REMARKS

AMENDMENTS TO THE DRAWINGS

FIG. 3

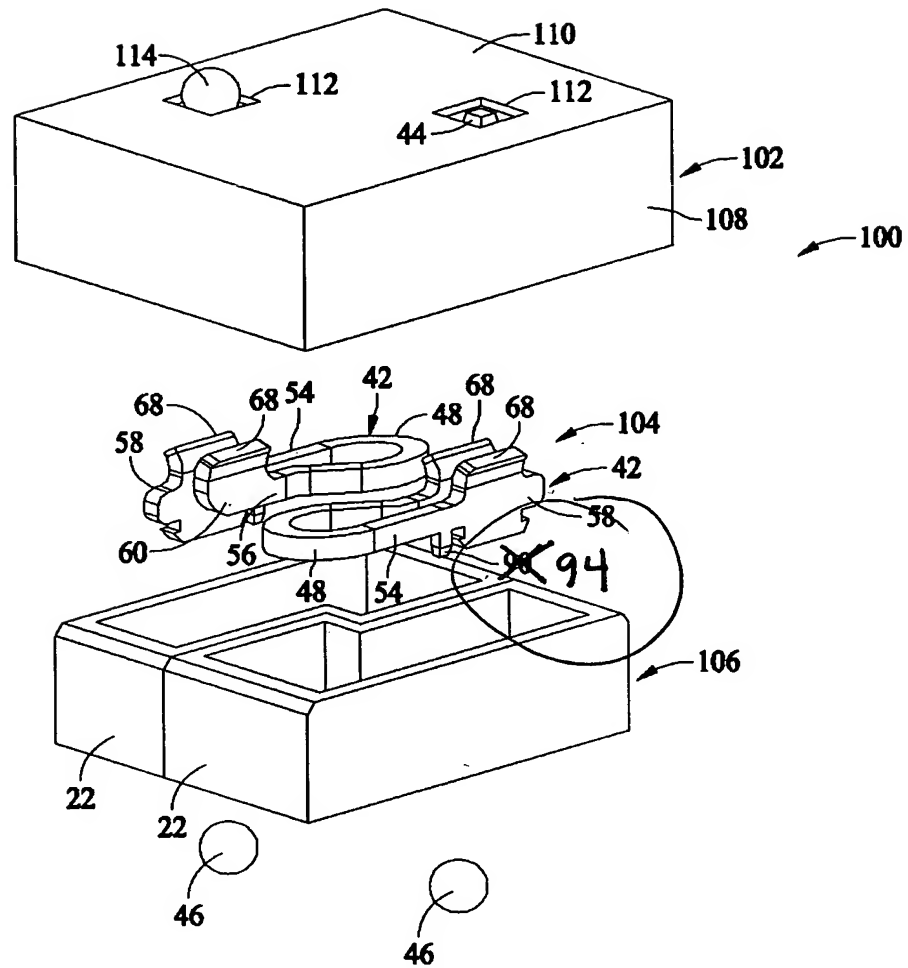
The attached sheets of drawings include changes to Figures 3 and 5. These sheets replace the original sheets for Figures 3 and 5. In Figure 3, reference numeral 90 has been replaced with reference numeral 94. In Figure 5, reference numeral 146 has been directed to the solder balls.
